Comments:

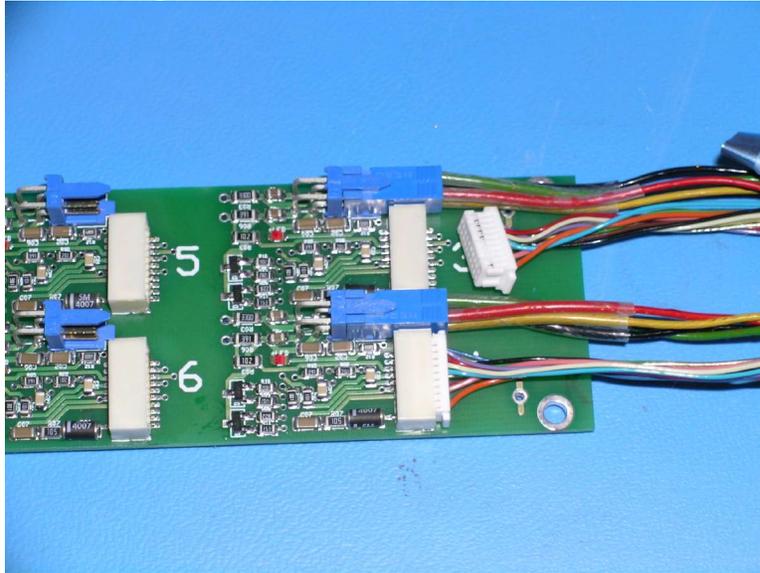
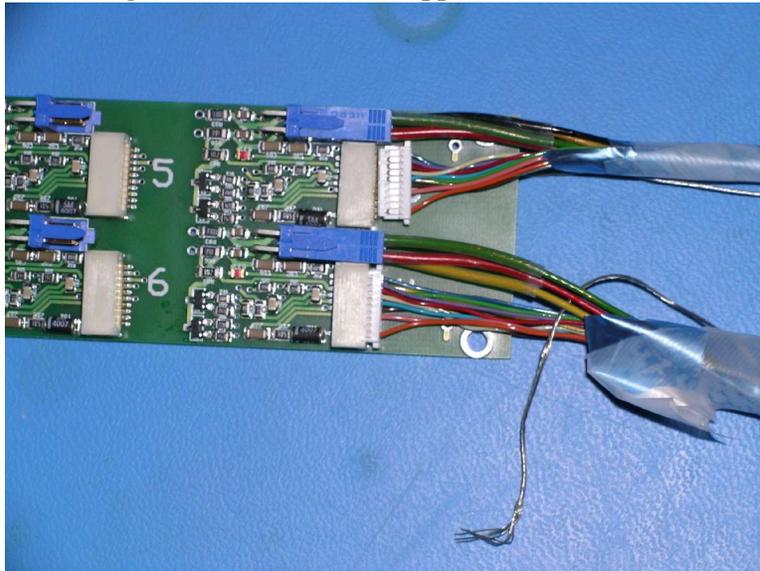
1. Electrical tests very fine for all: continuity of lines and isolation to neighbours.
2. 2 splices at limit length
3. 8 out of 10 splices thicker than specified. Is it a problem ?.
4. Strip back length:
 - One is smaller than specified (72.5mm) (cable 00003)

- Even if the specification is achieved, the difference in length between the 2 connectors can be greater than 2mm. It happens n 3 cables (00002, 00004, 00005).

In 00002, it looks like the dark blue wire is shorter than the rest (rework?) , making the length on this connector shorter. Idem for yellow wire in 00004.

- If I look at the cables connected to PPB1, I don't understand why this 2mm difference, the edge of both connectors are at the same level (maybe because of the expected routing?):
